## REMARKS

Appl. No. 09/521,588  
Appt. Dated 4/15/04  
Reply to Office Action Dated 1-15-04  
Annotated Sheet Showing Changes

FIG. 1

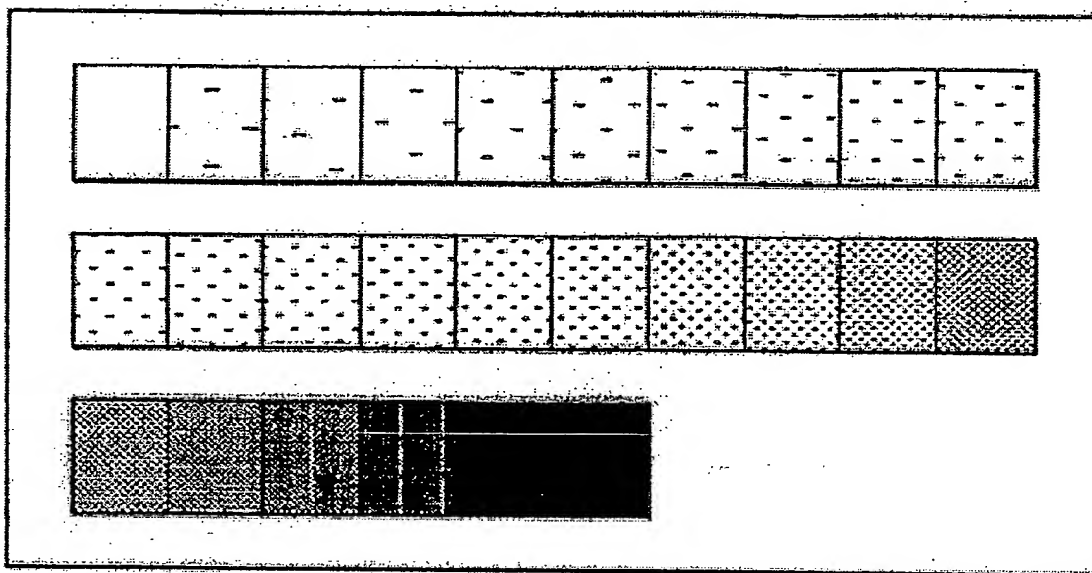
Regarding the drawings, Figure 1 has been amended to include the label PRIOR ART as required on page 4 of the application.

The amendments to Figures 1 and 2 are shown in red on the attached copies of the Figures.

PRIOR ART
